**SUBJECT:** NuScale Power, LLC Response to NRC Request for Additional Information No. 289 (eRAI No. 9215) on the NuScale Design Certification Application

**eRAI No.:** 9215

**NRC Question No.:** 06.02.05-10

**Figure 1: Bay Height**

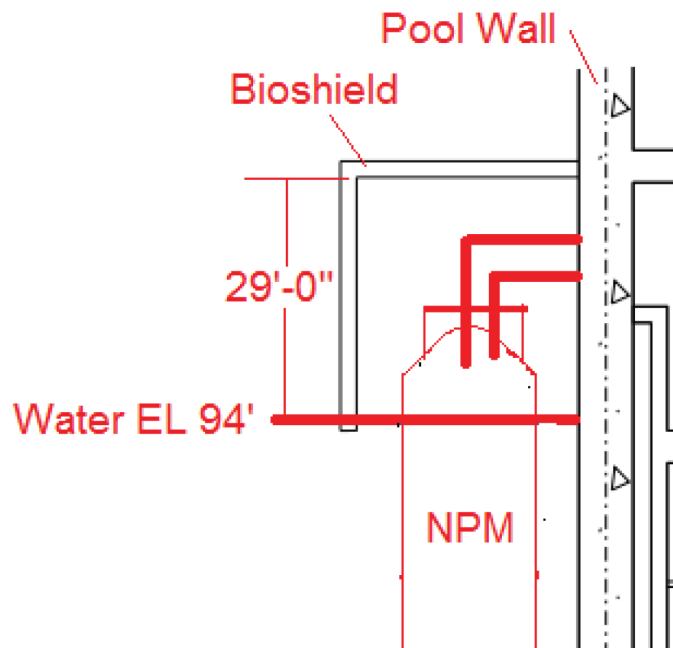
- 1) Describe the region / compartment above the containment vessel and below the bioshield, including clarifying the above statements. Provide the volumes, elevations, and shapes of each compartment. Provide dimensions and compositions of the solid structures (walls, etc.) that bound or define the compartment. Additionally and/or alternatively, provide drawings of or describe the gas-occupied compartment immediate above the reactor bay pool.

The NRC has correctly understood the configuration of the operating bay surrounding the NPM. Using FSAR Tier 2, Figures 1.2-19 and 3.8.2-3 as reference, Figures 1 and 2 of this response show that the volume created by the bioshield, operating bay and pool walls, and the water surface is as follows: the distance between the bay walls is approximately 19'-7" from inside face to inside face (Figure 2 below), the distance from the pool bay wall to the vertical portion of the bioshield is approximately 20'-1" from inside face to inside face (Figure 2 below), the distance from the pool water to the horizontal portion of the bioshield is 29'-0" from the water surface (EL 94') to inside face (Figure 1 below), and the containment vessel occupies space approximately 5'-2" above the water surface and is approximately 14'-9" in diameter. Above the module, space is occupied by various pipe, electrical/I&C SSC, and steel. This is the only compartment enveloped by the operating bay walls, pool wall, bioshield, and pool water surface, and the space/volume can be described as a cube with the upper module and supporting SSC occupying some of that space. The dimensions and compositions of the solid structures are the same for a single bioshield and stacked bioshield configuration.
